Change Order

PROJECT: *(Name and address)*
Mansfield ISD Jobe Middle School
GMP 1 - Flooring Renovations
2491 Gertie Barrett Road
Mansfield, Texas 76063

CHANGE ORDER INFORMATION:
Change Order Number: 001
Date: March 05, 2026

REQUEST FOR PRICING (RFP)

1 FINISH PLAN - AREA C - SECOND FLOOR - PHASE 1A

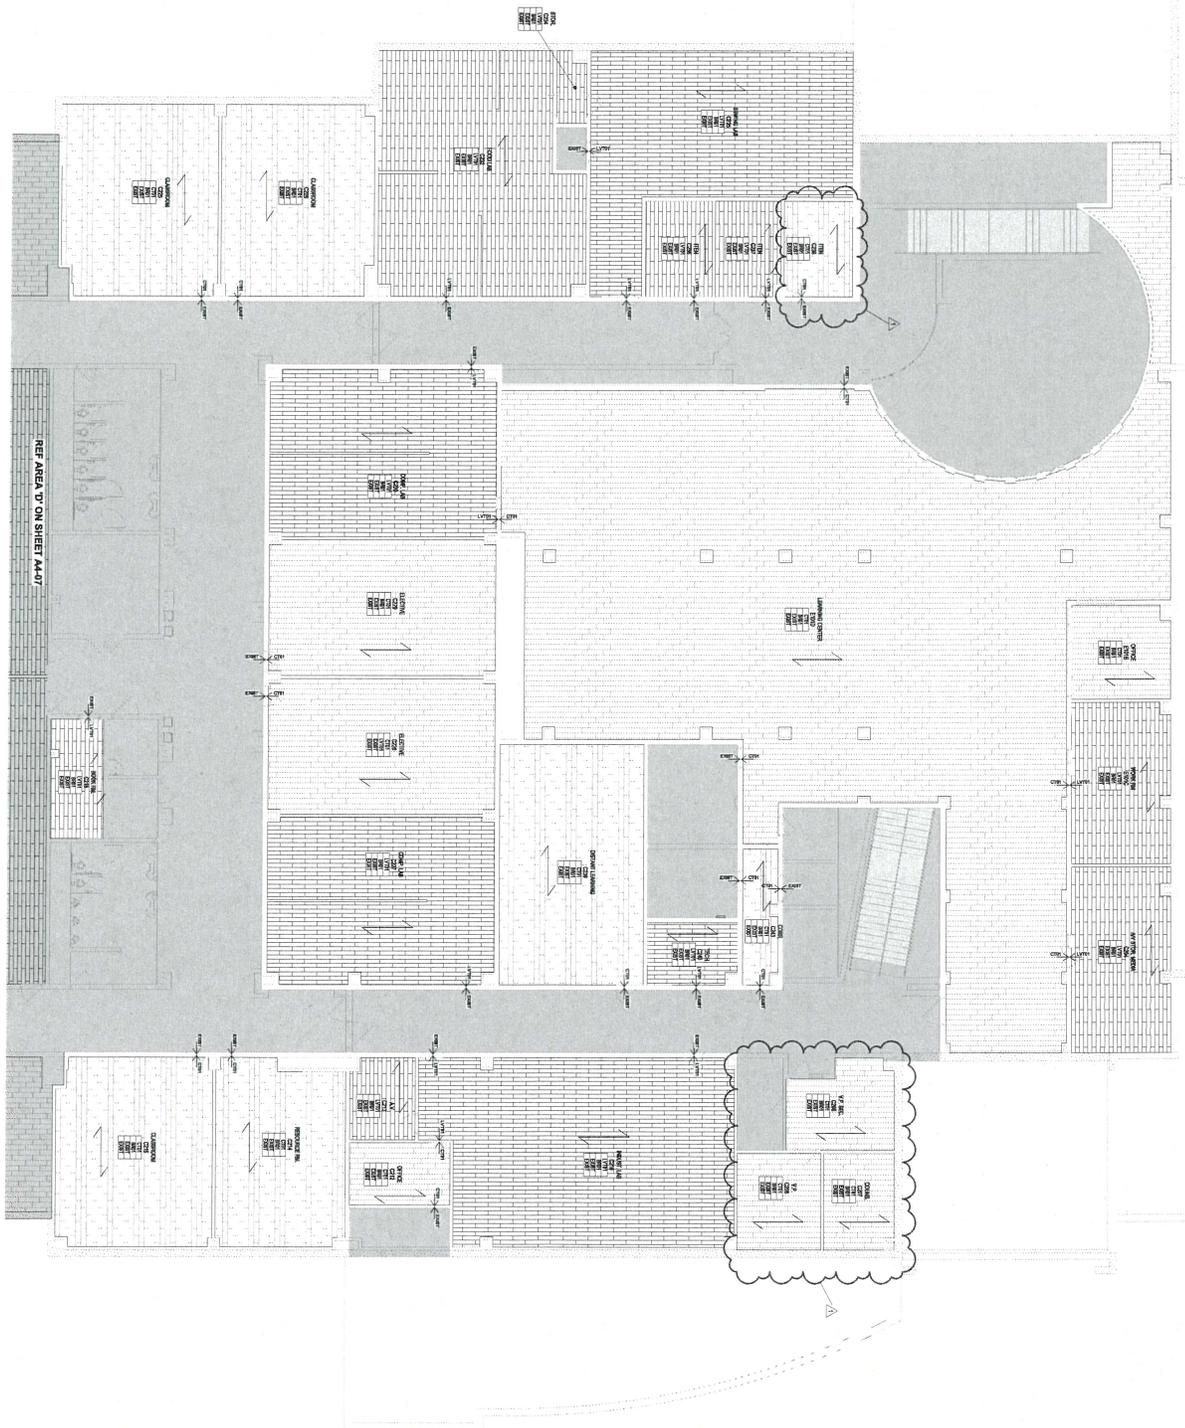
RFP No 1, Arch Item 6: To the Drawings, Sheet A4-06, "FINISH PLAN – AREA C – SECOND FLOOR,"

- 1) Included RM C238, C206, C207, C208 in flooring scope.
